STAFF MEMO

Date: October 11, 2021
To: Town of Milford Planning Board
From: Jason Cleghorn, Town Planner
Subject: **SP2021-04 Crosby Townhomes, Kling/Mengyuan Property Management, 159 Elm Street, Map 19, Lot 5.** Public Hearing for a major site plan application to construct a six (6) unit townhouse, multi-family residential project with related parking, drainage/stormwater management, landscaping, and lighting improvements.

Re: **Crosby Townhouses**
Site Permit
RMI Response Letter #1
Tax Map 19 Lots 5

Elevation from Elm St. (looking north)

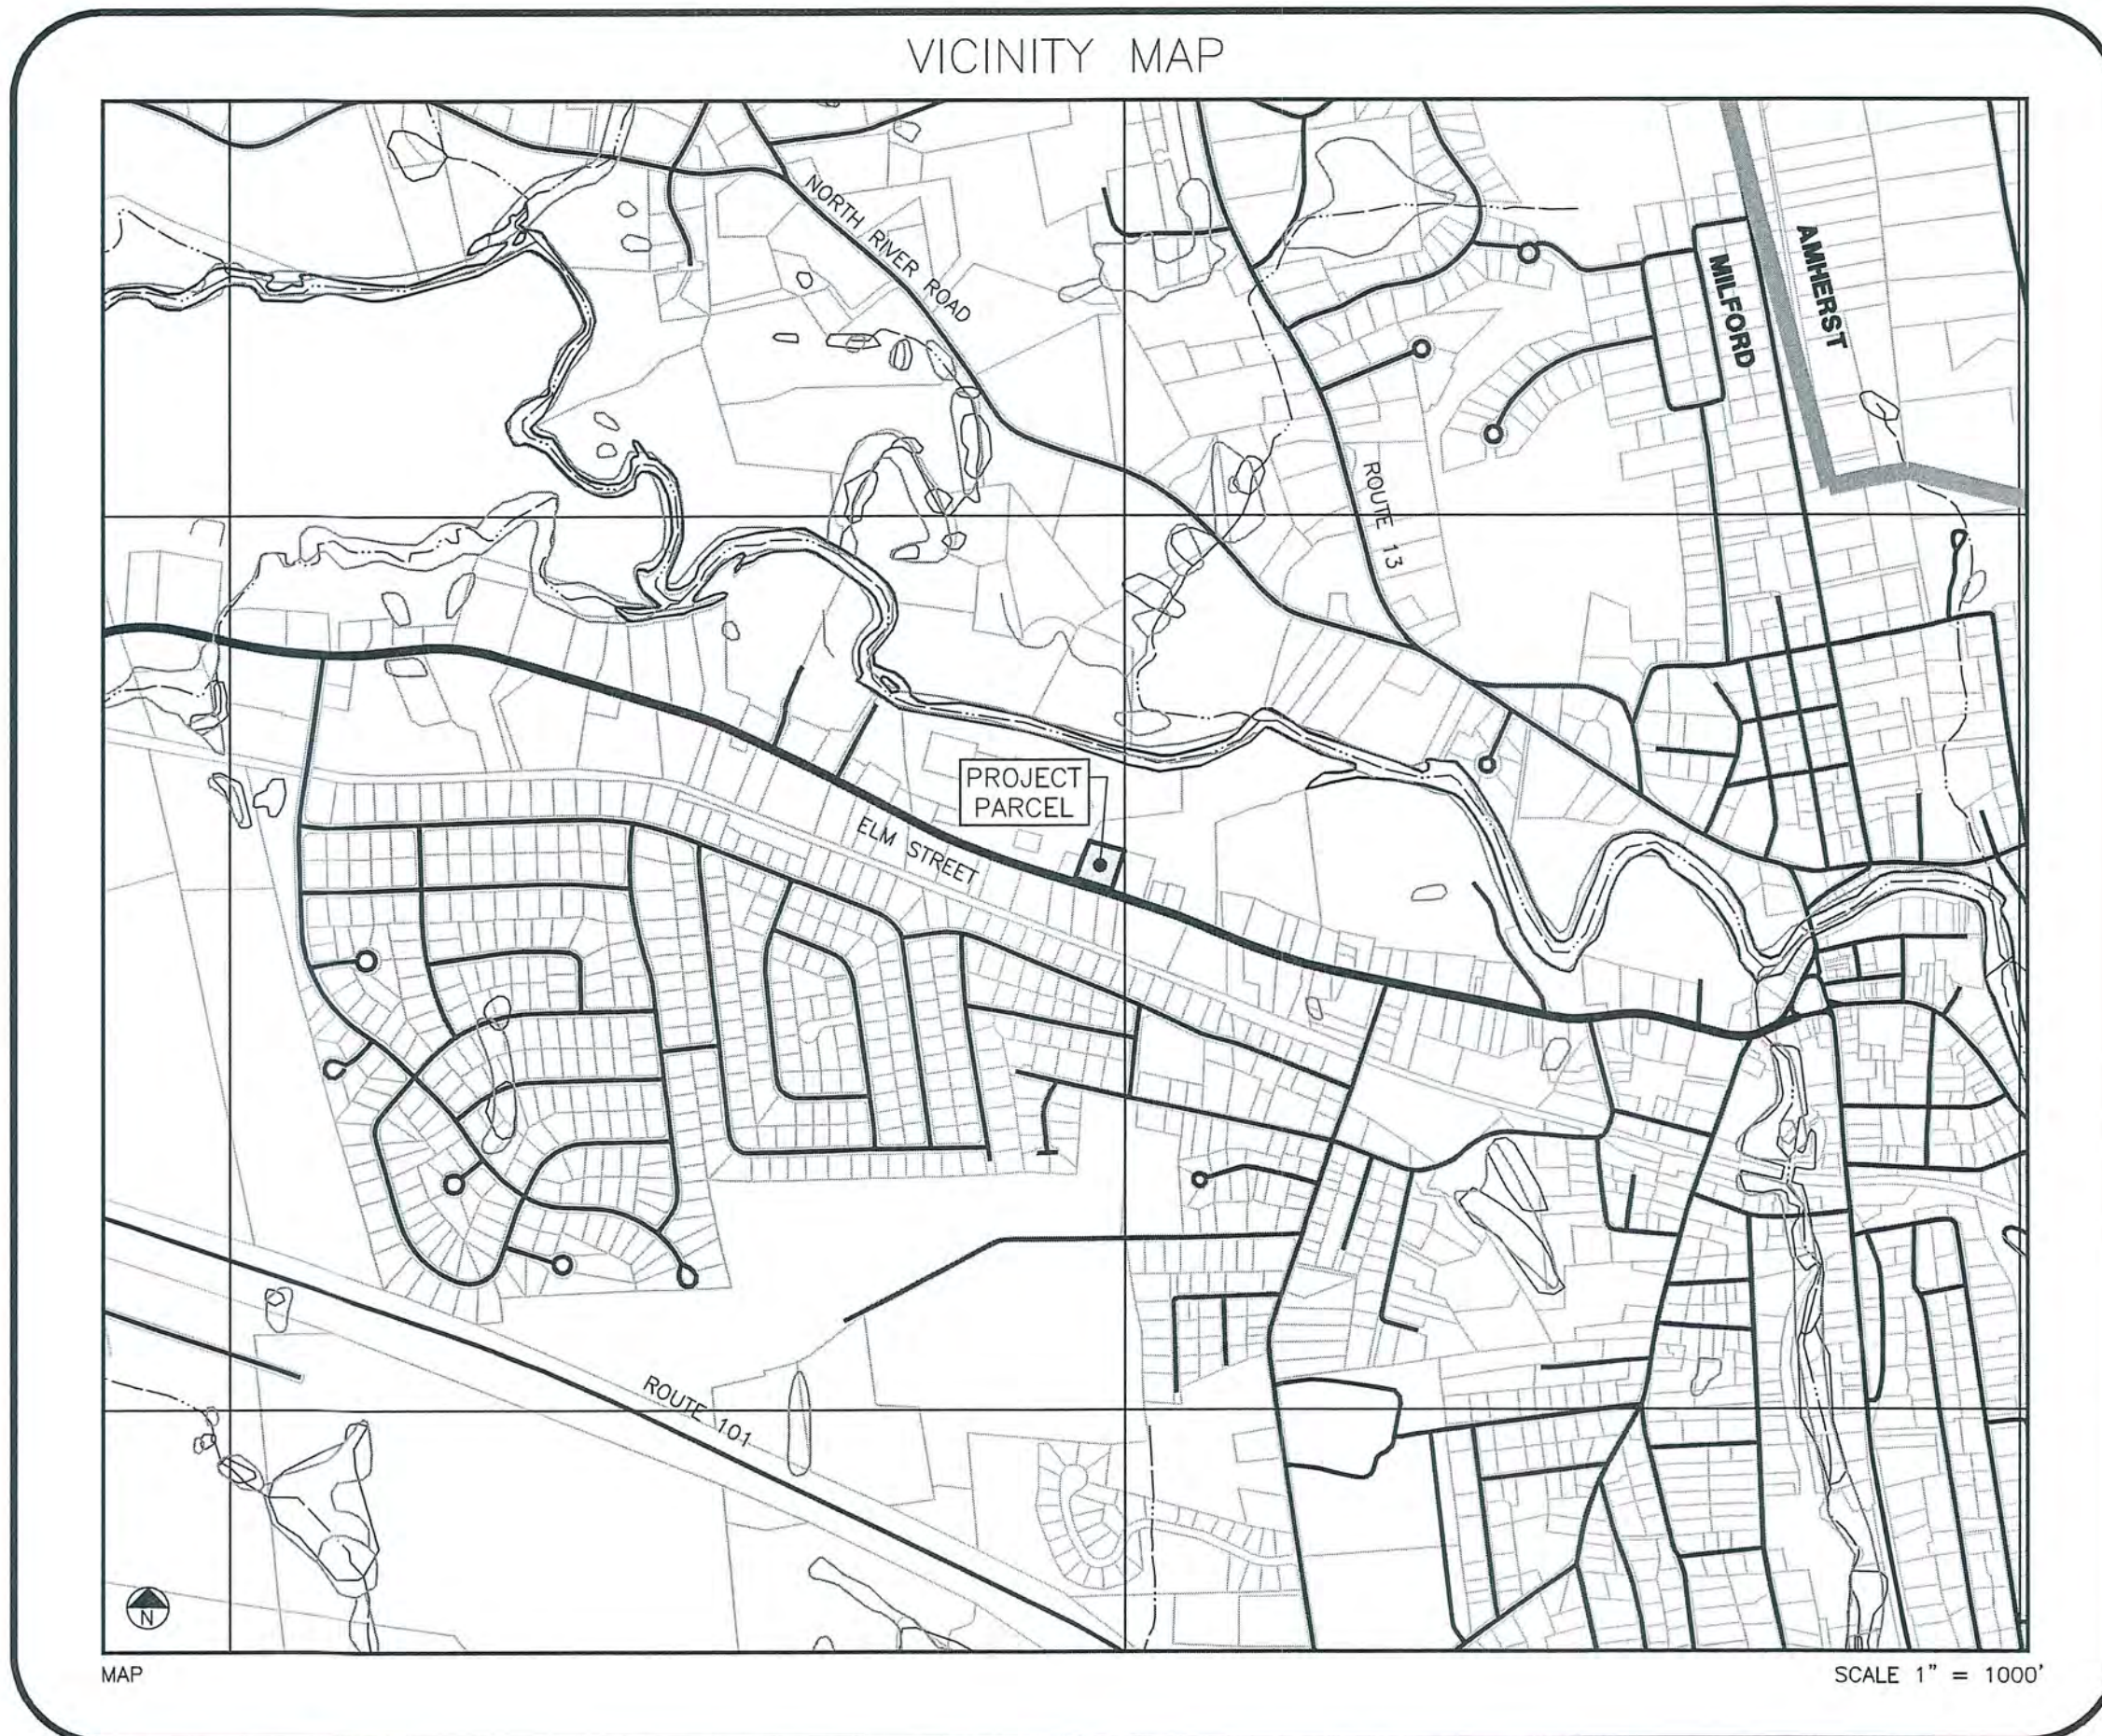
There have been minor changes to the building plane since the last iteration of the site plan. The front plane of the building has less articulation and presents in a flatter manner. See elevations at the end of this Staff Report and in the packet.

The last remaining comment pertained to the color elevations. Those have been submitted to the Town and are part of this package.

6. Elevations: Per § 6.04.2 of the Development Regulations, plans shall show all building elevations. The submitted elevation is only 1 view of 4. Please include the other three elevation views. While the parking is located in the rear of the building, the Town would still like to see these additional elevations. Staff may have additional comments pending the receipt of these elevations.

Finalized elevation will be provided prior to the next Planning board meeting scheduled April 20th, 2021.

SP-2
SHEET
FILE: 10839100.dwg
PROJECT 10839.00
SHEET NO. 3 OF 11

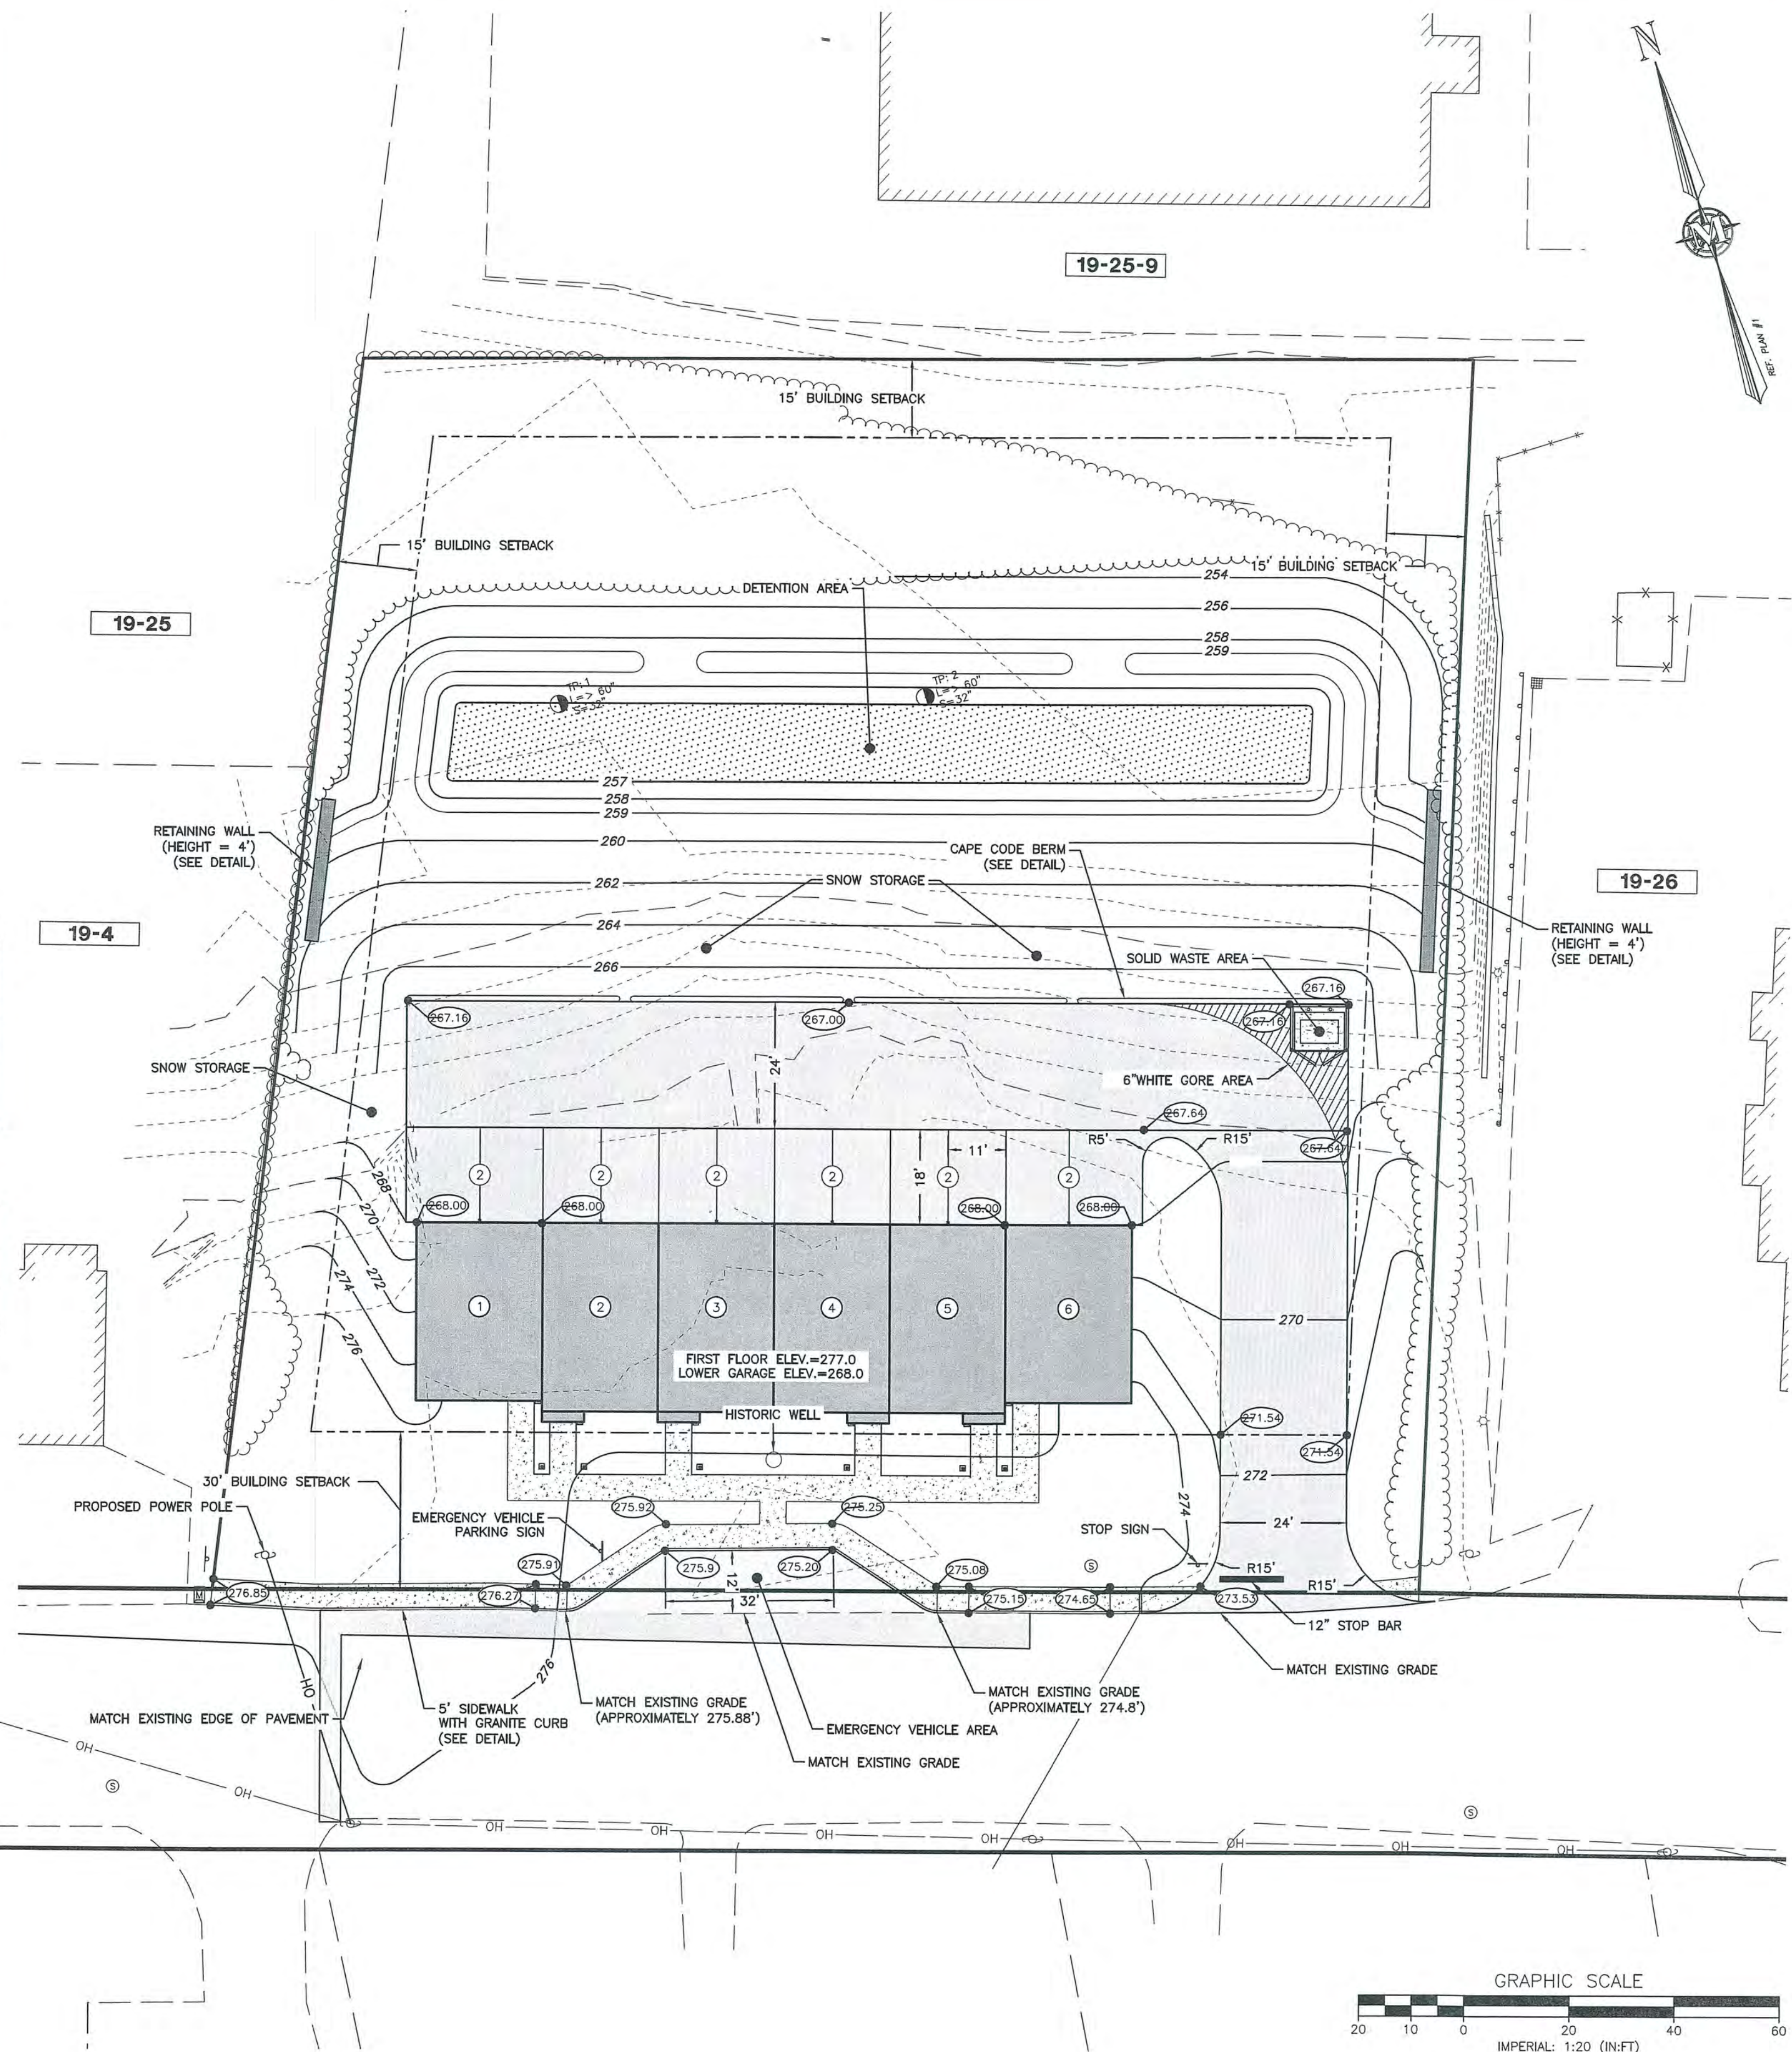
1. Sheet SP-2: Please revise the plan to include the location, size, and details of any signage related to the townhomes.

2. Sheet SP-2: Please revise the plan to include the location, size, and details of any exterior lighting. Per Town of Milford Development Regulations § 6.06, all outdoor lighting shall be downcast and directed such that no glare spills onto adjacent properties or roads. Consider adding a standard detail depicting the type of lighting to be utilized.

3. Sheet SP-2: Revise the land use summary to be more implicit regarding the amount of Open Space on the site. The current table just uses the term pervious and this table could be clearer.

4. Sheet SP-2: Add a note to the plan about the existence of Impact Fees related to the project. (§5.04 BB Town of Milford Development Regulations)

5. Sheet SP-2: Striping should be shown for the two (2) parking spaces per unit that are not contained within the garage in order for Staff to better evaluate vehicular movement flow through the rear of the site and for determination whether the corresponding drive aisle can be kept clear. Guidance can be found in § 6.05 of the Town's Development Regulations regarding the minimum size for parking spaces and their layout.

7. Given the roadway classification of Elm St. at this location combined with the Commercial zoning, and the goals of the Nashua and Elm Streets Corridor district, a sidewalk constructed consistent with § 7.03 of the Development Regulations should be added at the property's frontage for future connection(s). Design details and construction standards for sidewalks can be found in the Department of Public Works Infrastructure Design, Construction & Administration Standards and this detail should be added to the site plan.

The space was lengthened to 32' to have adequate room for both. See sheet 3 of the Construction Plans.

The note clearing defining that this is a townhouse-style condominium has been added to the plans. See sheet 3, general note 1.

Snow storage is provided in the rear and on the west side of the parking. Note delineating the snow storage areas have been added to the plans. See sheet 3 of the Construction Plans and General note 18.

The historic well has been preserved and will be featured at the front of the property. See sheet 3 of the Construction Plans.

The proposed lighting will be 1 downcast light at each entrance, 1 downcast light over each garage and one 3 foot post downcast light for each walkway. No glare will spill onto the adjacent property. See sheet 3 of the Construction Plans for lighting location and "Site Lighting Notes".

The table has been revised to clearly state that there is 65.5% of open space provide with this project. This is well above the minimum of 30% open space requirement. See sheet 3 of the Construction plan, table titled "Land Use Summary".

A note acknowledging the existence of impact fees has been add to the plans. See sheet 3, general note 2.

The outdoor parking spaces have been striped to help the staff evaluate the vehicular movement and parking. See sheet 3 of the Construction Plans.

Sidewalk along the frontage of the property has been added. See sheet 3 of the Construction Plan.

DETENTION BASIN - TYPICAL CROSS-SECTIONS SCALE: NONE **14** **D-3**

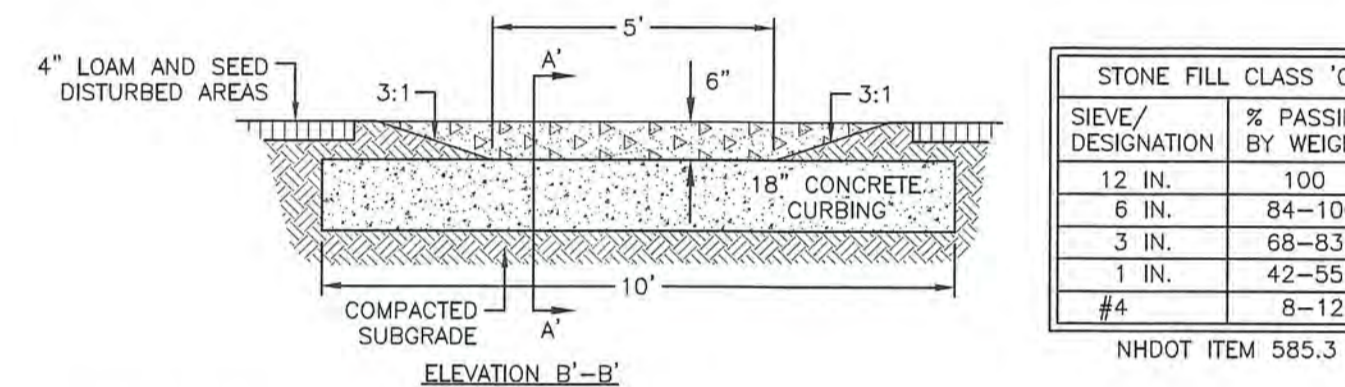
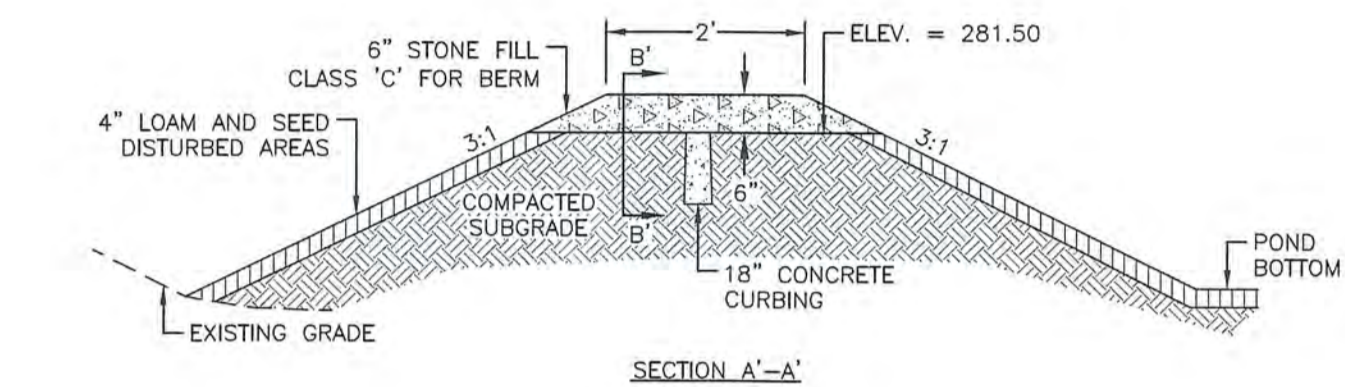
1. The sediment forebay in the stormwater basin is proposed as a long, linear forebay. It is not clear from the grading shown on the plans how that will be constructed and if adequate volume is provided in the forebay. Please update the Stormwater Basin – Typical Cross Section to include the forebay and dimensional and construction requirement of stone check dam.

A cross section has been added to the Construction plans with all the requested information above. See sheet 5.
